**SYDNEY WEST CENTRAL PLANNING PANEL**

**COUNCIL ASSESSMENT REPORT**

<b>Panel Reference</b>	2016SYW082
<b>DA Number</b>	DA/863/2016
<b>LGA</b>	City of Parramatta
<b>Proposed Development</b>	Demolition of six (6) dwelling houses, construction of two (2) x six (6) storey residential flat buildings comprising 61 units, excavation of two (2) level basement car park accessed from Hepburn Avenue, providing 88 spaces; Strata subdivision of the residential units and associated landscape works, fence and tree removal.
<b>Street Address</b>	2-2A Hepburn Avenue & 199-203 Carlingford Road, Carlingford Lots 1 and 2 DP 845101, Lots 1 and 2 DP 879689, Lot 2 DP 30015, and Lot 3 DP 419712
<b>Applicant/Owner</b>	SWA Group
<b>Date of DA lodgement</b>	20 April 2016
<b>Number of Submissions</b>	4
<b>Recommendation</b>	Approval
<b>Regional Development Criteria (Schedule 4A of the EP&amp;A Act)</b>	Pursuant to Clause 3 of Schedule 4A of the <i>Environmental Planning and Assessment (EP&amp;A) Act 1979</i> , the development has a capital investment value (CIV) of more than \$20 million.

<b>Report prepared by</b>	Matthew Hedges, SJB Planning (NSW) Consultant Planner, City of Parramatta.
<b>Report date</b

**Figure 3.** Breach of building height.

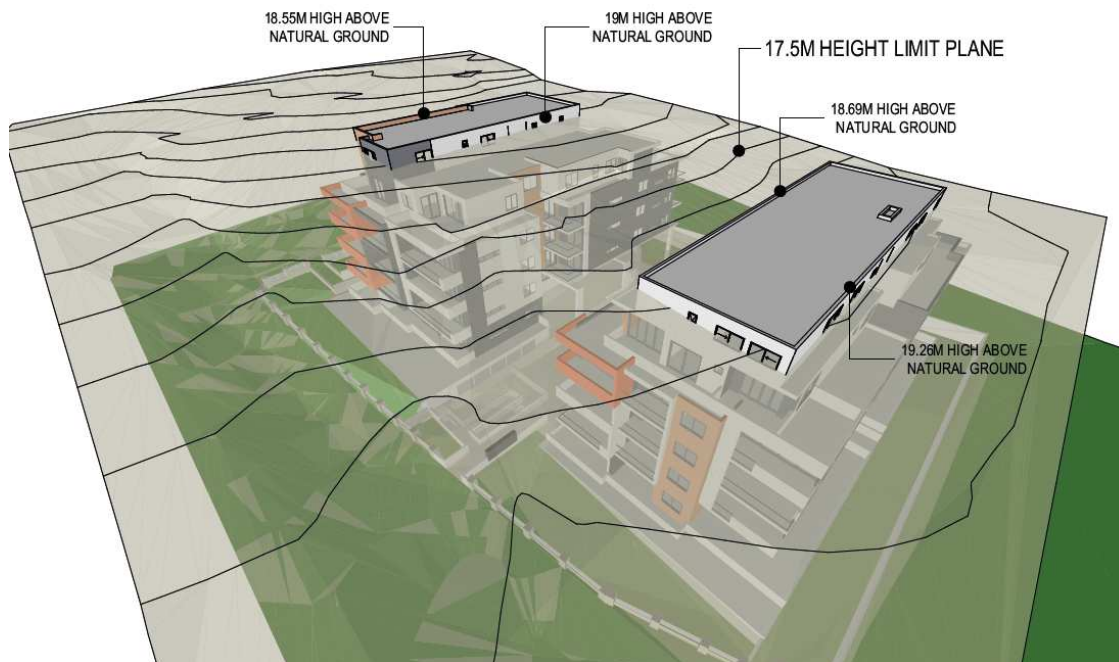
## Clause 4.6 Variation Assessment

The decision in the Land & Environment Court case of *Four2Five Pty Ltd v Ashfield Council [2015] NSWLEC 90*, suggests that 'sufficient environmental planning grounds' is more onerous than compliance with zone and standard objectives. The commissioner also established that the additional grounds had to be particular to the circumstances of the proposed development and not merely grounds that would apply to any similar development.

The environmental planning reason for allowing the minor departure from the standard is based on site specific issues which do not exist on similar sites which would restrict its orderly and economic development if the standard was upheld. Therefore, it is considered that the proposed variation is within the public interest
